BUILDING CODE OF AUSTRALIA CAPABILITY STATEMENT - Rev A

Property: Sydney Opera House – DA2 Submission

- **Joan Sutherland Theatre Accessibility**
- **Joan Sutherland Theatre Follow Spot Room**
- **Eastern Accommodation**

Figure 2 – Lift 03 Stair 26 Changes

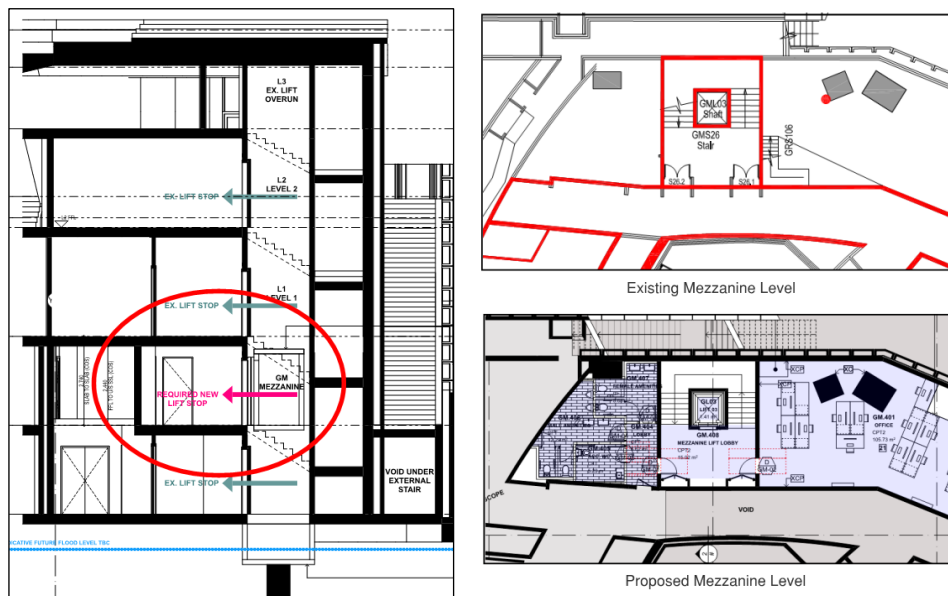
Lift 03 Stair 26 - Proposed alterations to Lift 03 are to the extent that cause a requirement for an upgrade consideration to be given to Stair 26 and Lift 03, for compliance with BCA 2016, see Figure 2. i.e. new storey lift access/stop to GM Mezzanine. Fire Safety Engineer to review and confirm the feasibility of Performance Solutions. Refer Table 6 below for specific non-compliances.

Figure 2 – EO Beam Ceiling Height Clearance

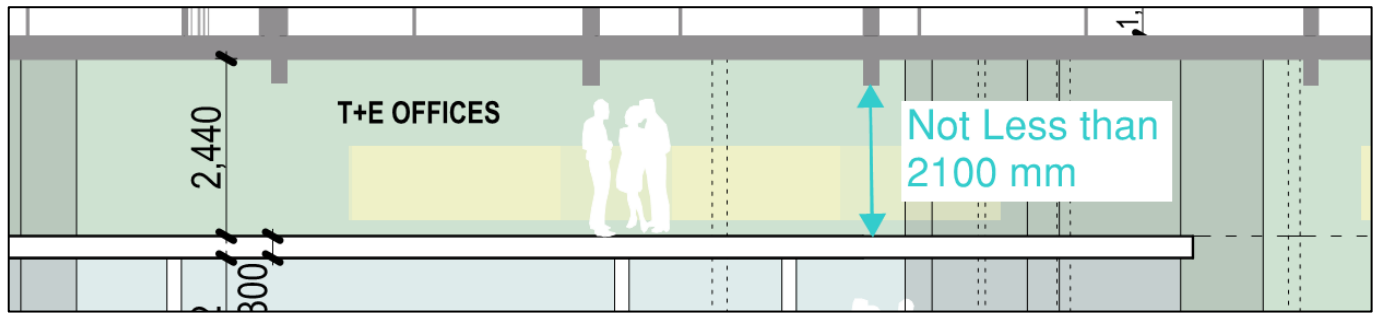
Further assessment of the pending detailed plans is required, i.e. grid beam height dimensions to be nominated. It is noted that the grid beams in the mezzanine offices will protrude not lower than the 2.1 m limit, but these must create a finished floor to ceiling height of less than 2.1 m (FC), see Figure 2 below. The ceiling is to be painted white in support of amenity due to the overall lack of 2.4 m clearance.

Figure 2 – Varying dead end related travel distances.

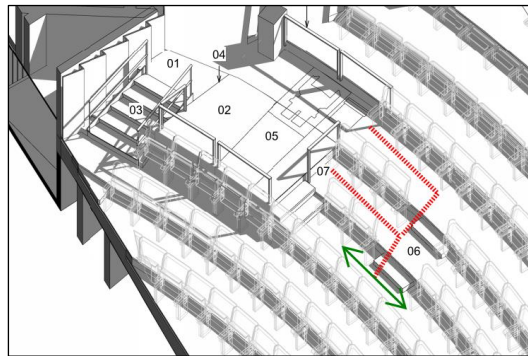
- Seating Upgrade - Travel distance assessment required due to the increased travel distance due to the new wall/door construction. And the blocking, or creation of dead end spaces, of isles when only part of the row is to be used/activated for wheel chair seating only, see Figure 2 below. Please provide a single scaled (accurate scale bar) plan illustrating the required exits and the proposed works for further assessment. Refer 3D Figures 1 – 4 from the ARUP Equitable Egress Strategy dated 4 March 2016, we need a 2D plan of this area illustrating the proposed design and Podium external exit doors.

Figure 3 – Fire Stair 2 Changes

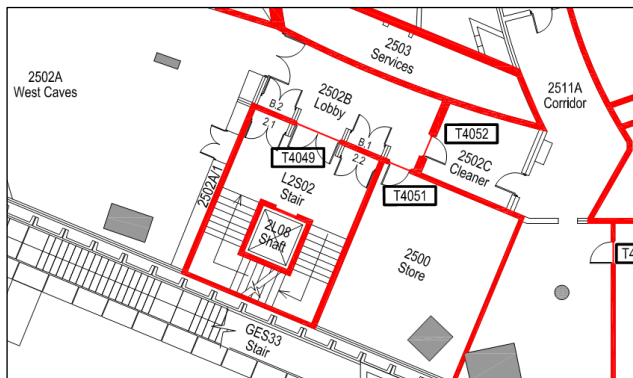
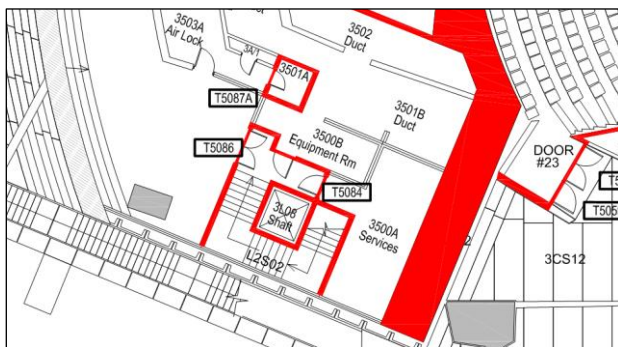
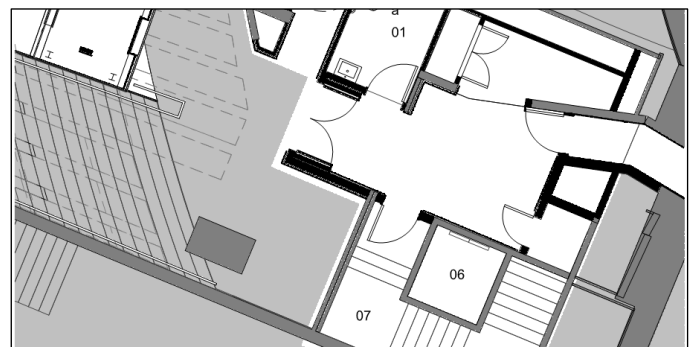
Northern Foyer – Proposed alterations to Level 2 Stair 2 / Lift 8 lobby see the requirement for an upgrade consideration to the Stair 2 and Lift 8, for compliance with BCA 2016, see Figure 3 below illustrating the changes as Level 2 & 3 however it is noted that Level 3 changes are an obvious improvement. Fire Safety Engineer to review and confirm the feasibility of any justifiable Performance Solutions. See Table 6 below for the relevant BCA issues to be considered.

Figure 4 – Lift 31 Barrier/handrail requirements

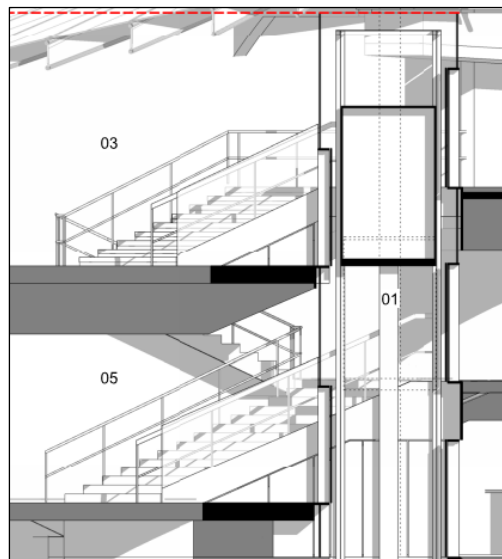
Lift 31 - The balustrade positioned around the tunnel opening in the existing stairs is not permitted to contain gaps in excess of 125 mm. Compliance appears to be illustrated with the inclusion of compliant safety glass or other transparent material, however further enhance details will be required prior to the issuance of the Crown Building Works Certificate for absolute confirmation. See Figure 4 below. (BCA Clause D2.16)

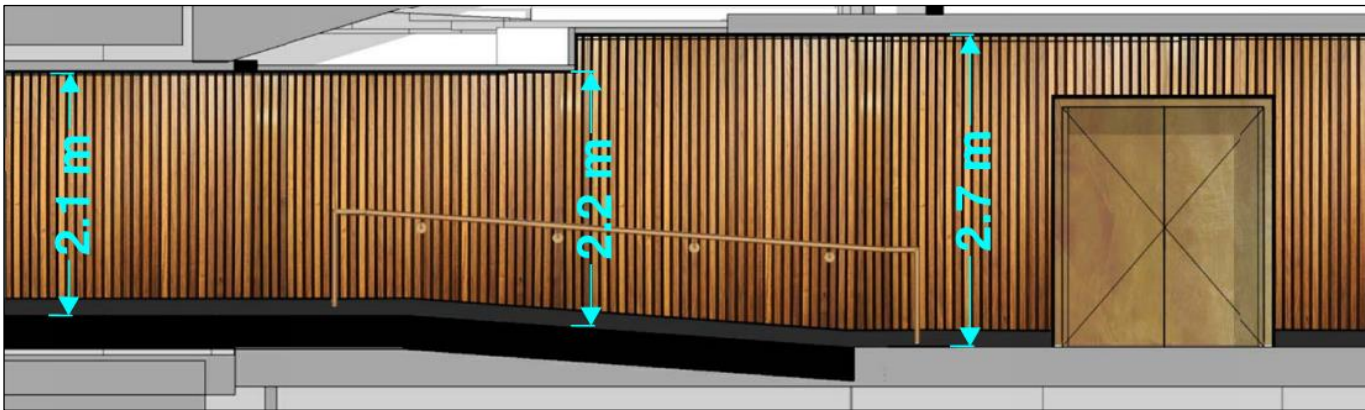
Proposed changes to the existing sanitary facilities will require the new works to comply the provisions of the BCA *inter alia* AS 1428.1-2009. However it may not be proposed to provide ambulant facilities in relation to Sanitary Facilities Upgrade project, rather a drop down rail in the unisex accessible facility west. This design will require a Performance Solution justifying BCA Performance Requirement FP2.1 from an accredited Access Consultant.

An overall reassessment of the Opera House's Facilities will be required if the proposed facilities reduce the number of existing facilities or the design increases the current occupant capacity in anyway. It is understood that the number of facilities will actually be increasing cross the Renewal Projects and that the occupant numbers will be decreasing due to the sacrificed able persons seating spaces to allow for wheelchair spaces. The Sydney Opera House Project Managers will be providing a Letter of Confirmation accordingly.

Figure 5 – Level 2 & 3 Passageway Low Ceiling Height

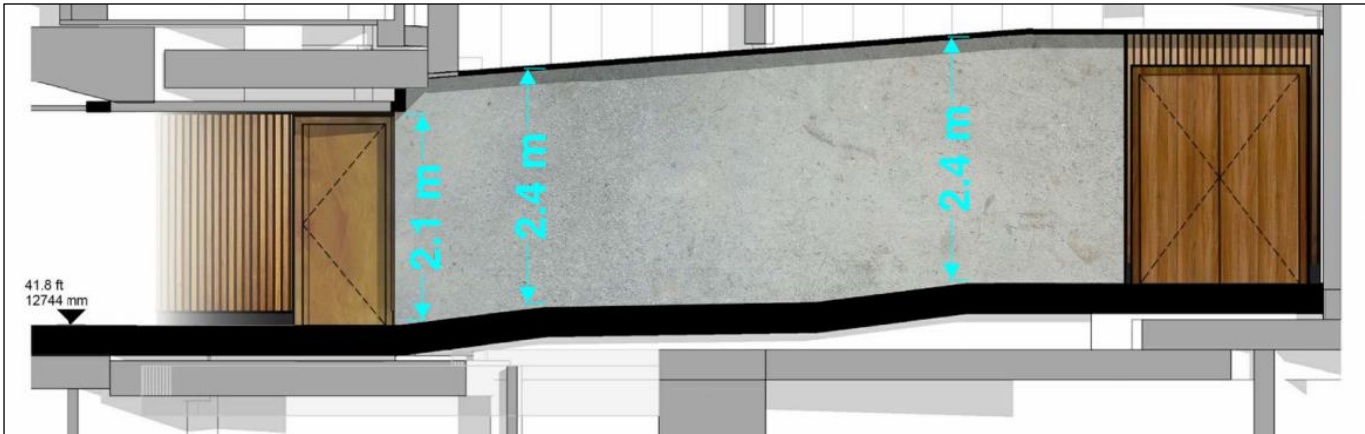
Northern Foyers – The proposed Level 2 & 3 passageways/tunnels will have a low ceiling height, less than the required 2700 mm, see Figure 5 Below. An Ergonomics Consultant will need to comment on the feasibility of a justifiable Performance Solution. This is not considered a fire safety matter as the majority of the space exceeds 2.0 m.

Figure 6 – Additional Guardrail Requirement

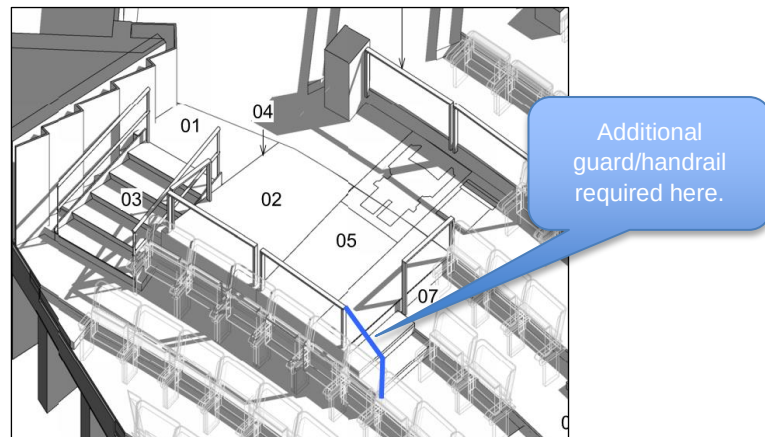
Further developed detail in the area of the temporary step up to the wheelchair platform is required, see Figure 6 below. There are a number of other areas where handrails are yet to be illustrated to new steps within the theatre, a separate highlighted handrail/guardrail plan should be provided for further review and comment.

- NSW H101.14.3 Guardrails at Cross Overs – The cross-over guard rail are to be no less than 750 mm above finished floor level. Design change required.
